December 17, 2021

Subject: Informal Dam Inspection
Highland Lake Dam
Town of Highland Lake, Alabama
MBA Reference Number: G21-047.00

Figure 2: Approximate Location of Observed Seepage at Toe of Downstream Slope

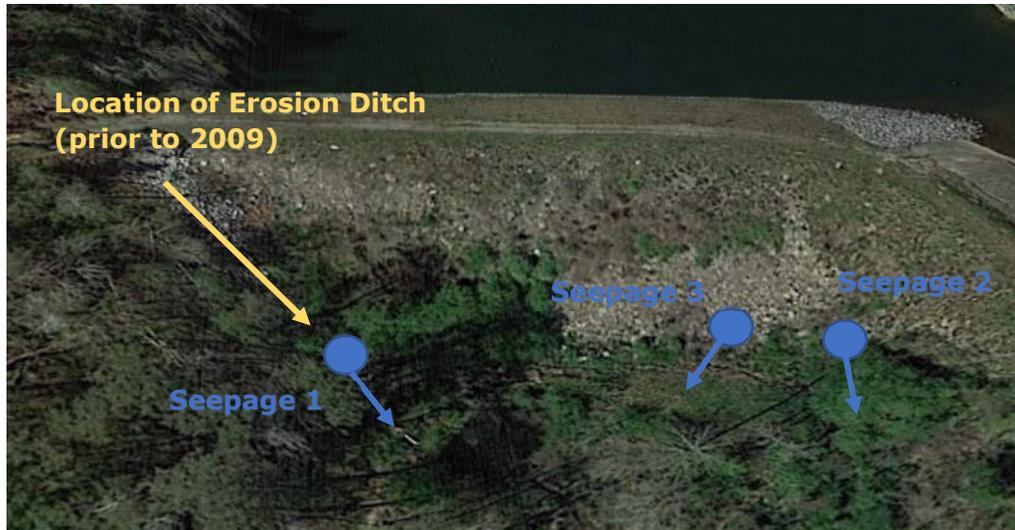
- Downstream Toe Area: The toe area of the downstream slope primarily consisted of large sandstone boulders and no erosion was observed at the slope/ toe contact. No signs of movement or depressions were observed at the toe. Water seepage was observed at three (3) locations (See Figure 2), and the following was noted:

- Seepage 1 observed in the Southwest corner at the toe of the general area of the limestone riprap. Flow at Seepage 1 consisted of approximately 0.5 gals/min. Mr. Hayden stated the seepage from Seepage 1 appears to be a result of water from the western hillside and not from the lake. Prior to installing the riprap, an erosion ditch had been created between the dam and the natural grade due to the constant seepage from the western hillside. In 2009, the drainage ditch at the base of the dam and along the slope were backfilled with limestone riprap by Mr. Hayden to prevent additional erosion.

- Seepage 2 was observed at the location of the abutment corner in the middle length of the downstream slope. Estimated flow consisted 3 gal/min.
 - Additional seepage (Seepage 3) was observed between Seepage 1 and 2. Seepage flow appears to be less than 1.0 gal/min.

- The majority of the toe area consisted of soft, saturated clay. The depth of soft clay is unknown; however, based on probing with a steel rod, the soft conditions extended to at least 3' below the existing surface.

As previously discussed, water seepage was observed at three (3) locations at the toe of the downstream slope. During our site visit, the water seepage was minor and does not appear to be affecting the lake level. However, the soils at the base of the downstream slope appear to be saturated as a result of the seepage.

Controlling Water Seepage: As a minimum, water seepage should be controlled so the foundation soils at the toe of the slope do not continue to be saturated. Trench drains should be considered to collect water from the toe of the slope to the existing creek in order to control the water.

Continue Monitoring Water Seepage: As previously discussed, we are unaware of the origin of the water seepage, and the location in the southwest corner maybe seepage from the western hills. We recommend continuously monitoring the seepage to determine if seepage flow is increasing. If seepage flow increases, additional stabilization measures would have to be considered.

Figure 5: Approximate Location of Observed Seepage at Toe of Downstream Slope

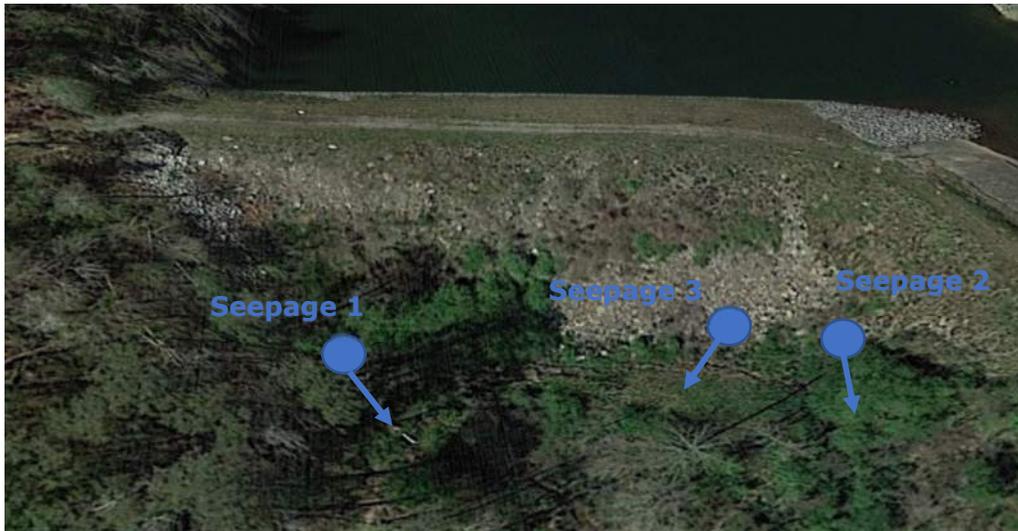
Seepage or Wet Area Along Contact: Figure 5 shows the location of observed seepage. The following was observed at the seepage areas:

1. Seepage 1 observed in the Southeast corner in the general area of the riprap. Estimated flow was approximately 0.5 gals/min.
2. Seepage 2 was observed at the location of the abutment corner in the middle length of the downstream slope. Estimated flow consisted 3 gal/min.
3. Additional seepage (Seepage 3) was observed between Seepage 1 and 2. Estimated flow was less than 1 gal/min
4. The majority of the toe area consisted of saturated clay. I was able to penetrate my 3' probe rod to the handle bar due to soft soils.

Figure 8: Concrete Spillway with Location of 36" Drawdown Pipe

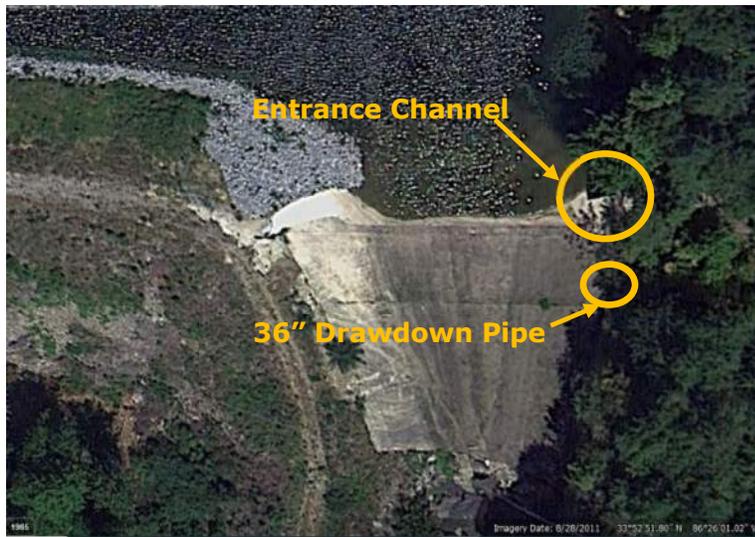
Joints: One concrete joint is located 12' below crest. The joint has noticeable erosion. The joint is at the same elevation at the exist of 36" Drawdown pipe. Joint needs to be sealed.

Seepage was observed at the toe of the downslope concrete apron between the concrete and underlying rock. Same seepage noted in October observation.

1. The concrete joint located along the concrete apron has noticeable erosion and likely has water seepage during summer months. We recommend the joint to be sealed.

2. Water Seepage at Apron Toe: Water seepage was observed between the apron toe and the underlying sandstone. The water seepage is low and does not appear to be affecting the lake elevation. We understand larger water seepage issues have been observed in this area that required stabilization measures such as installing the concrete cutoff trench. The cutoff trench appears to be working effectively; however, we recommend monitoring the water seepage to determine if the seepage is increasing.
